**Meeting of the Central Valley Flood Protection Board
June 28, 2013
Staff Report**

Union Pacific Railroad Bridge 104.18 (Segment A), San Joaquin County

Consider approval of Permit No. 18841.

PROPOSED BRIDGE - UPSTREAM FACE PROFILE (SEGMENT A ONLY)

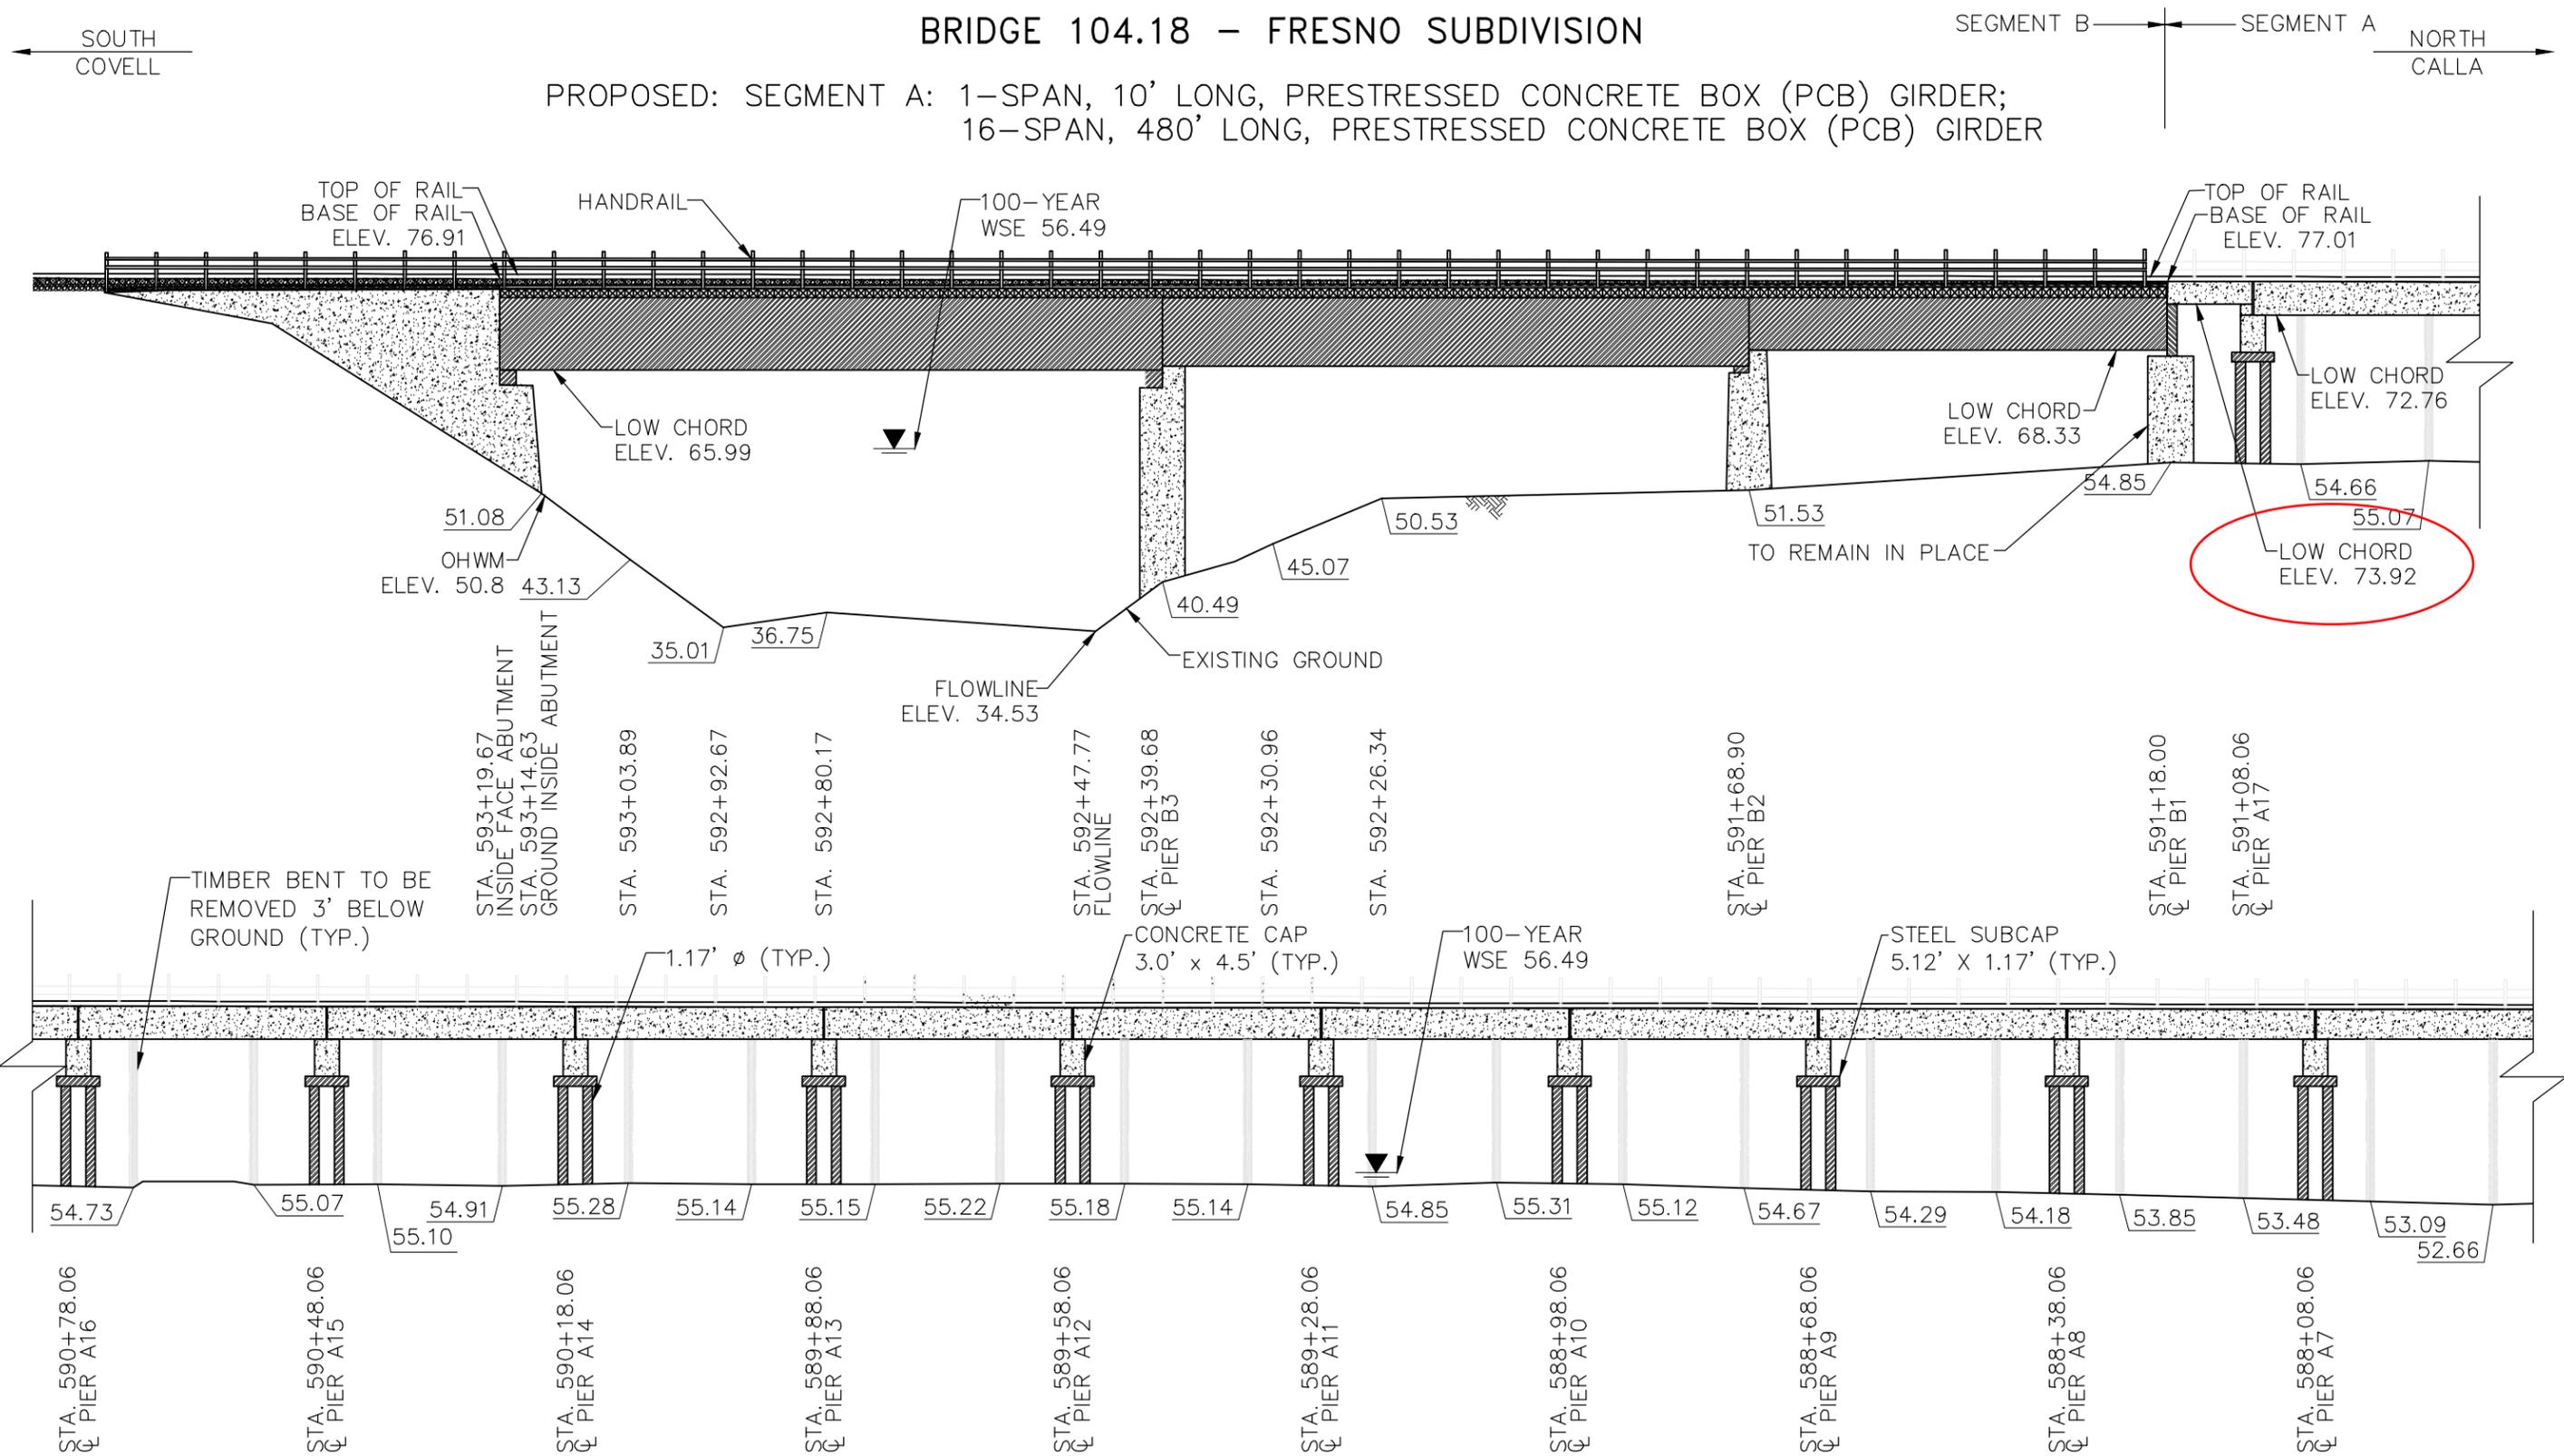
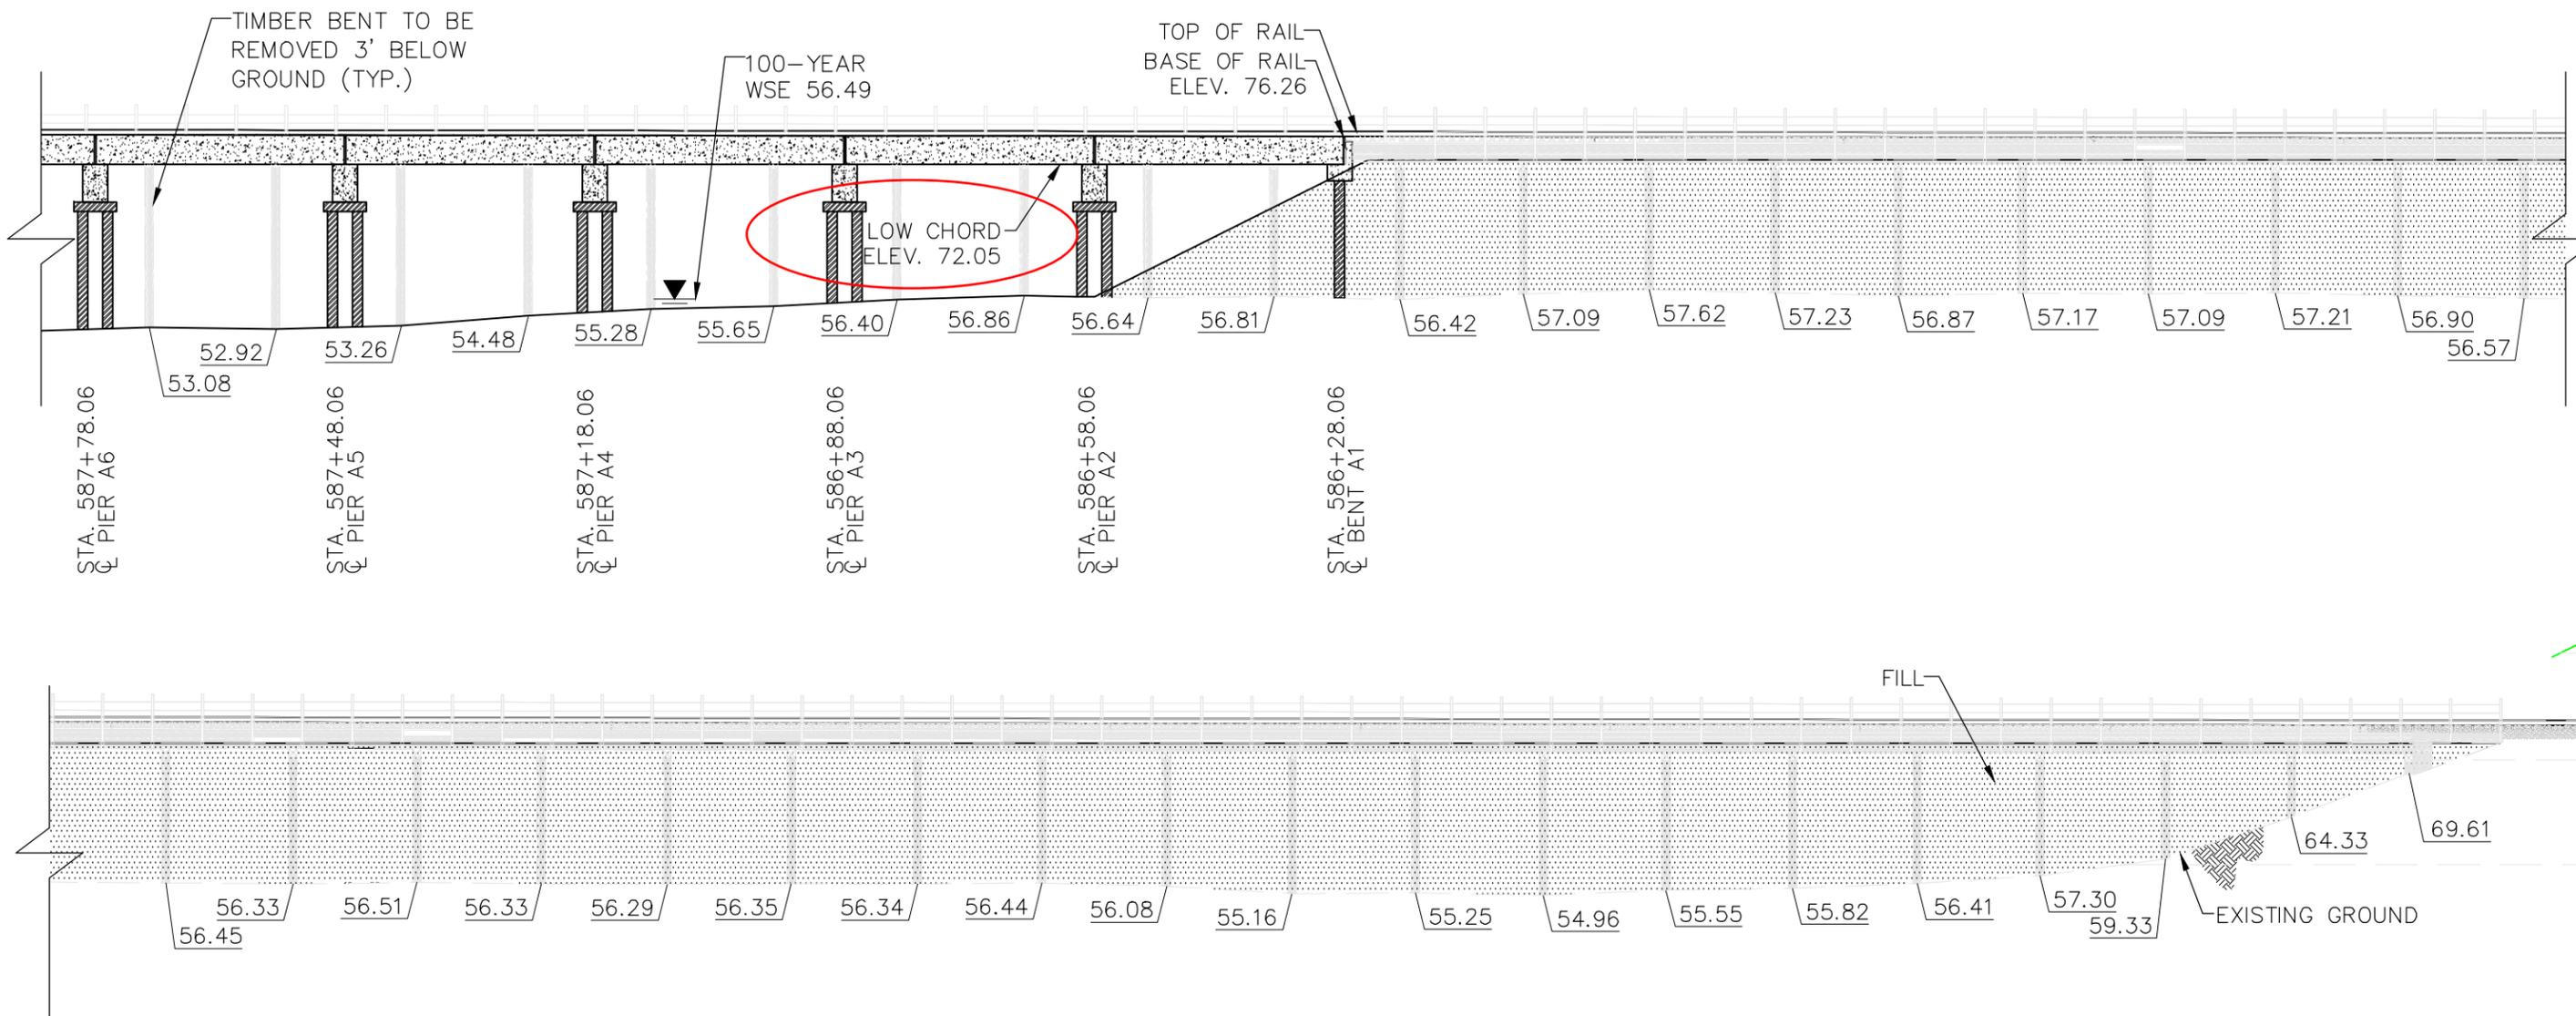
- 2) CCR 23, § 128 (a)(16) requirement for the bridge soffit being no lower than the existing soffit. Board staff believes this concern is adequately addressed in Section 5.2 above.

The second concern is lowering the low chord elevation of the proposed bridge. The county is referring to the low chord elevations at Pier B1, where the existing Segment A low chord elevation is 73.84 and the proposed low chord is 72.76. The proposed low chord elevation is lower due to the longer concrete replacement spans. It should be noted that the lowest low chord of the existing bridge along Segment A is at elevation 71.86 (TT North Abutment) and the lowest proposed low chord is at 72.05 (TT North Abutment), which is approximately 0.2' higher than existing. The HEC RAS model uses the lowest low chord elevation (most conservative) along Segment A. The 100-year WSE is at elevation 56.49, which is 15 feet below the proposed Segment A low chord elevation. I've attached an elevation view for your reference (Figures F-3A/B and F-4A/B).

Regarding your second question, the lowest low chord of the existing bridge along Segment A is at Elev 71.86 and the proposed low chord is at 72.05, approximately 0.2' higher. The HEC RAS model uses the lowest low chord elevation (most conservative). We always use the lowest, most conservative low chord elevation in our hydraulic analysis.

Extent of the fill
(blue hatched area)

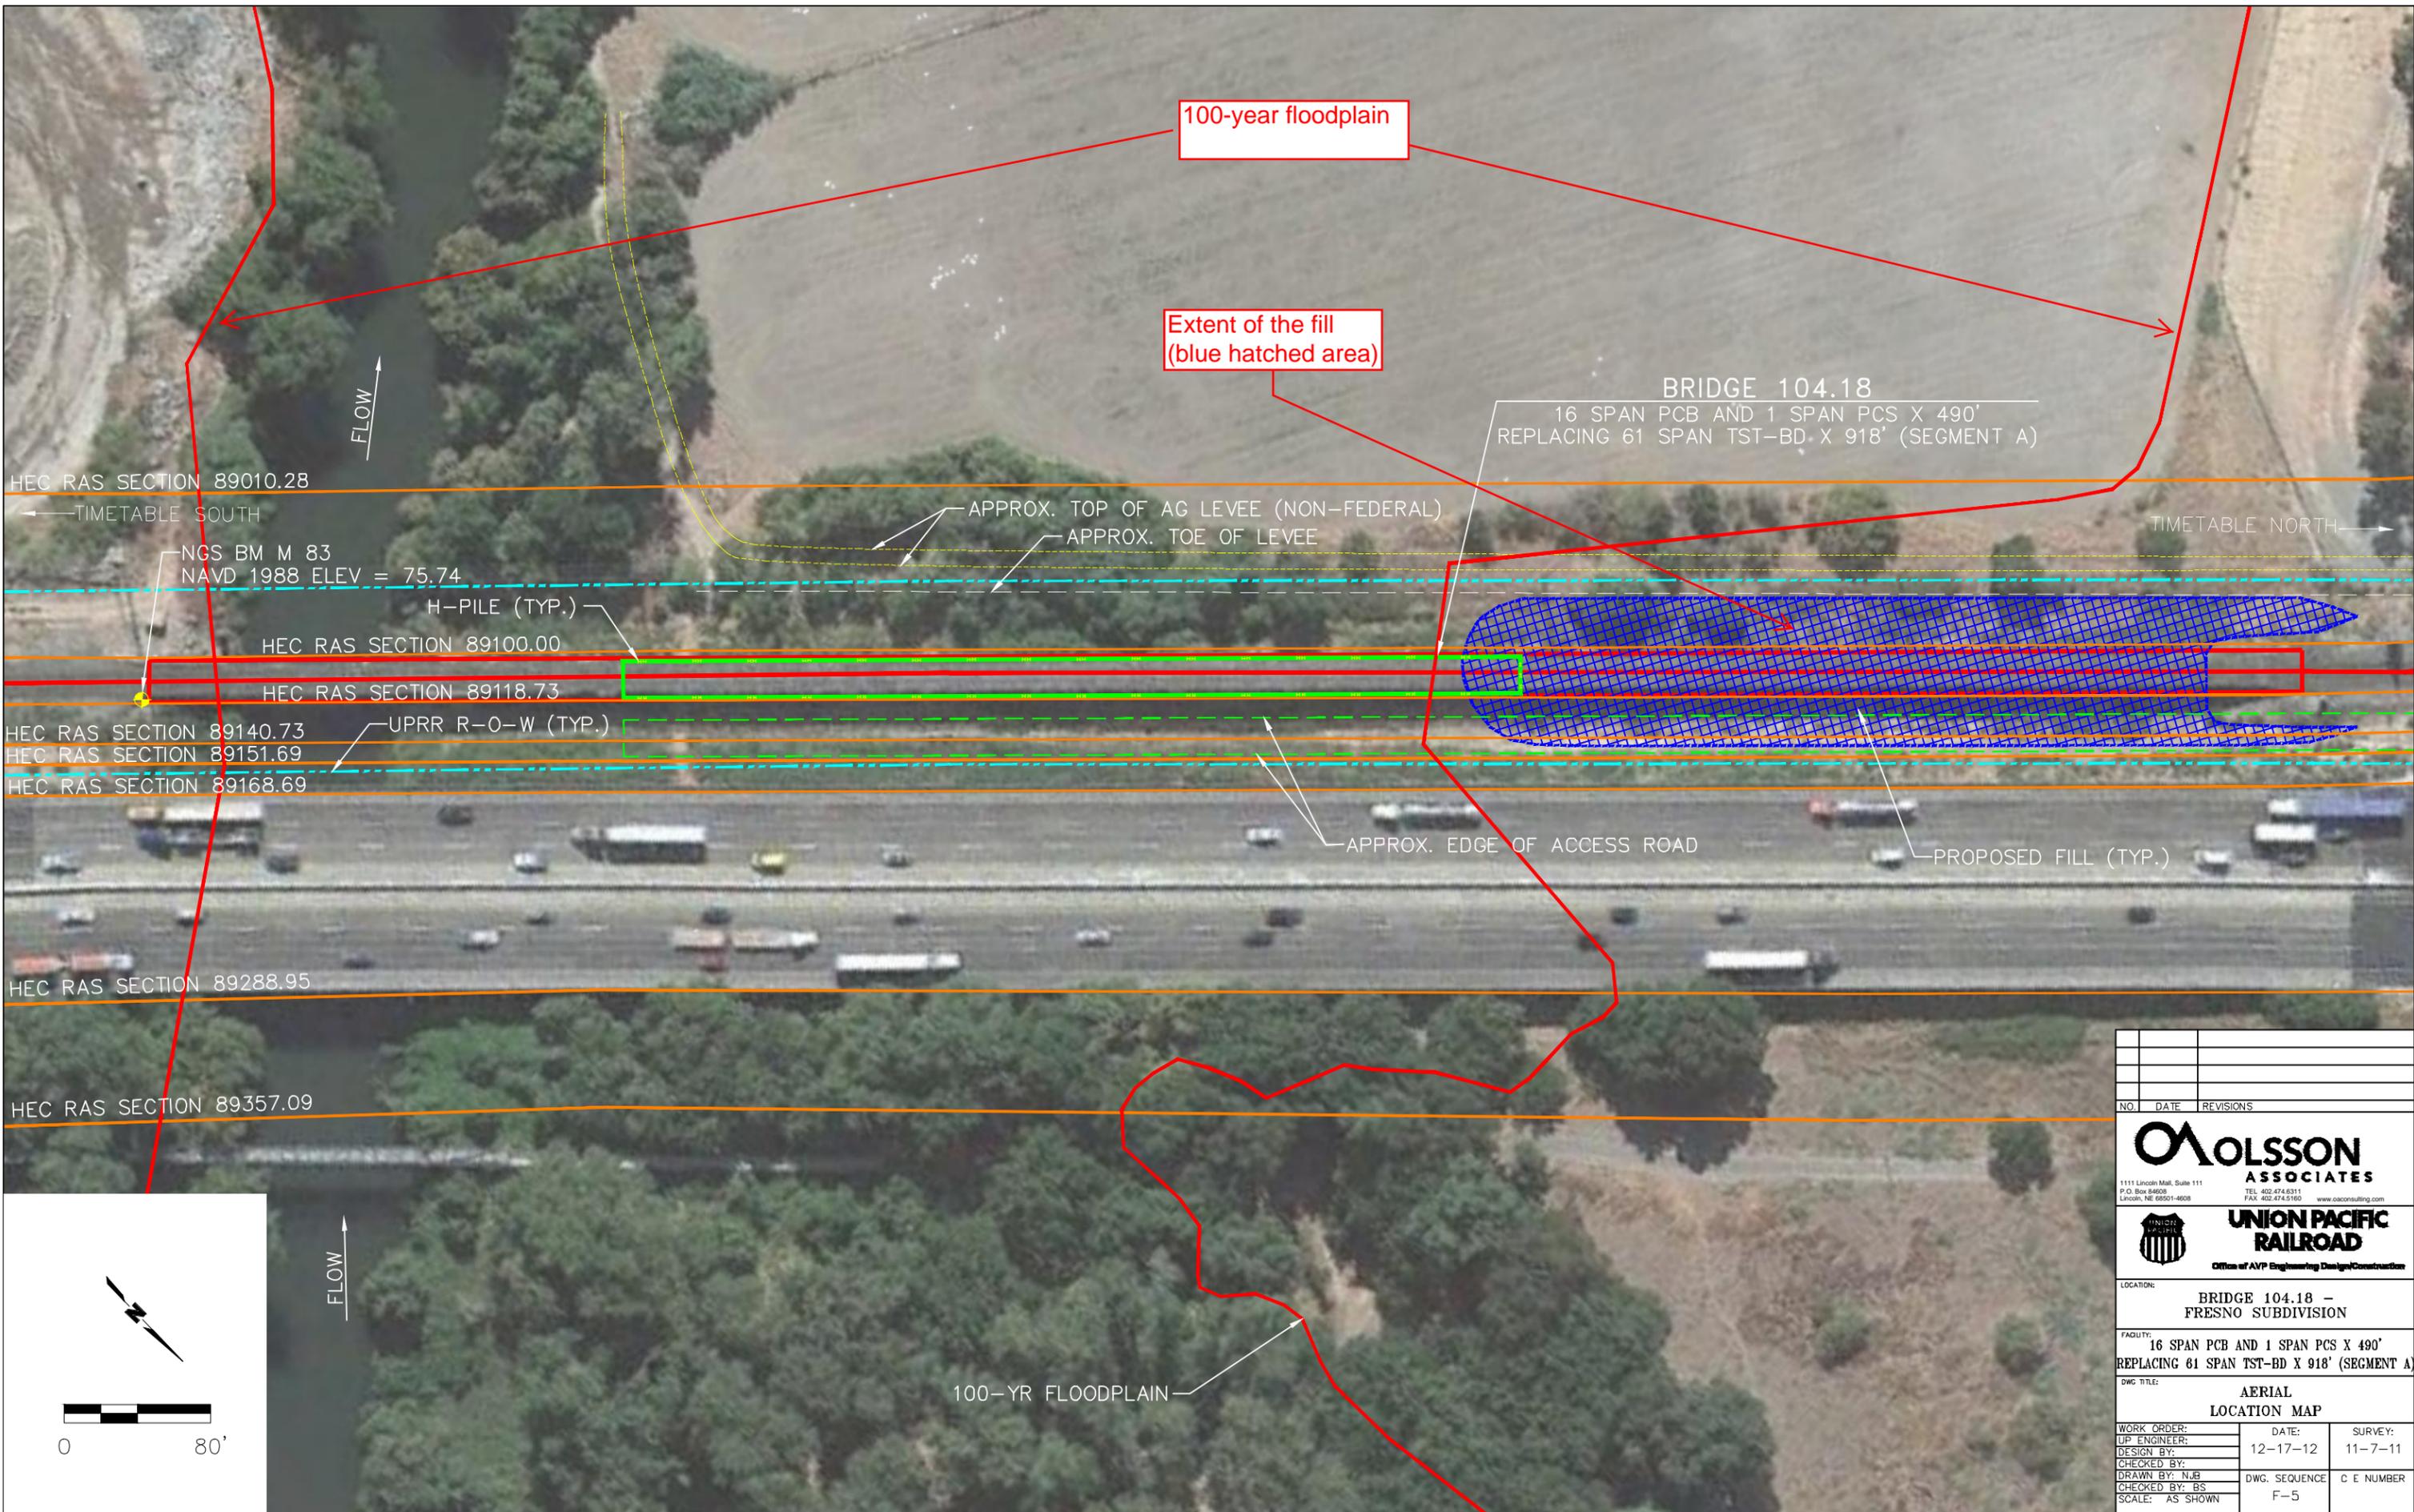
In addition, approximately 125 cubic yards of riprap will be placed along the bridge sloping abutment. All fill material will be placed at elevations above the 100-year floodplain. Attachment D provides a plan view of the proposed fill material (blue) with respect to the 100-year floodplain (two nearly vertical red lines) (Attachment D).

- San Joaquin County had two concerns with the proposed project:
 - 1) Placement of fill within the Board's Designated Floodway. Board staff believes this concern is adequately addressed in Sections 5.2 and 5.3 above.
